iEi Products Product Change Notice

Phase-out Model: SPXE-9S-R10 & SPE-9S-R10

Status: Running Change

SPE-9S-R10:

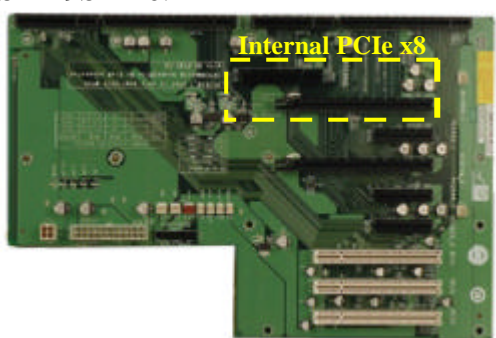
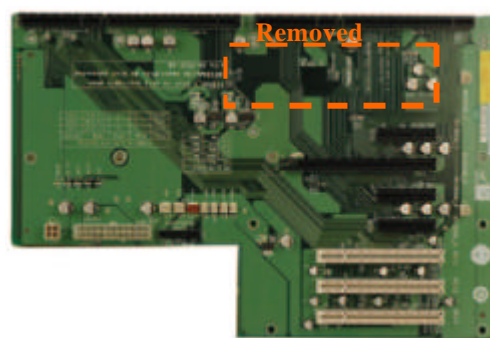
We would like to notify you for the phase-out models will be replaced by SPXE-9S-R11 and SPE-9S-R11. Because of the two particular internal PCIe x8 slots which were used for the end product SPCIE-3200AM2, they should be removed on current backplane boards to avoid any concern about their functionality. You can refer to the comparison pictures as below.

Model Name	Configuration
SPXE-9S-R11	7 slots PICMG 1.3 backplane with 1 PCIe x16(x8 signal), 3 PCIe x4 and 3 PCI
SPE-9S-R11	7 slots PICMG 1.3 backplane with 1 PCIe x16(x8 signal), 2 PCIe x4, 2 PCI-X and 2 PCI
